## replacement parts industries, inc.

## RCK116 TIMER KIT (30 MIN) INSTALLATION NOTES AND TIMER WIRING DIAGRAMS

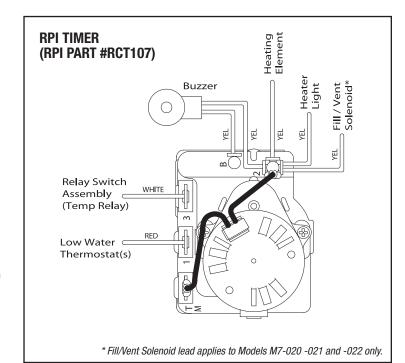
- It may be necessary to drill holes to mount new Timer. On some units, a nut is used to secure the timer to the front panel. On these units, it is necessary to drill two new holes on the front panel to secure the new Timer. To begin, from the center of the shaft hole, at the 12:00 position, measure 9/16" upwards, make a mark, and center punch. Next, at the 6:00 position from the center of the shaft hole, measure 9/16" downwards, make a mark, and center punch. At the center marks for each of the hole, drill a 3/16" hole. Use two #8-32 x 5/16" screws to secure timer.

- Connecting electrical leads. See Timer Wiring Diagrams and note that the #2 contact and the "B" positions are reversed on the RPI Timer when compared to the OEM Timer.

- If Wire Harness is too short. When upgrading to this newer style Timer (RPI Part #RCT107), the original wire harness may be too short. To extend the length, install the enclosed Wire Harness (RPI Part #RCH117).
